AB McLAUCHLAN :: WELLIVER METAL

**Service Bulletin #07-88
December 5, 1988**

**Attention: Parts Manager and Service Manager
RE: High Pressure Check Valves (part # 500-044)**

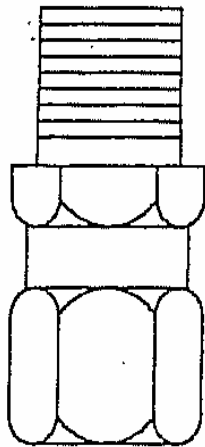
The new style hardened Valves do not always provide "Zero Leakage" which is required on Hand Pumps (to prevent "Bleed Off" from the cylinders). Starting at paver serial number H-10107-B-8 we are reverting back to our original check valves in ALL HAND PUMP applications. The Hand Pump check valves will be part # 500-044. The hardened seat check valves (now to be used in D-550 Pavers ONLY) will now be part # 550-108.

The two check valves are readily identifiable by sight. When a customer orders 500-044 check valves, it will be NECESSARY to determine what model paver they are going to be used on and supply the proper one. DO NOT INTERCHANGE these two different check valves.
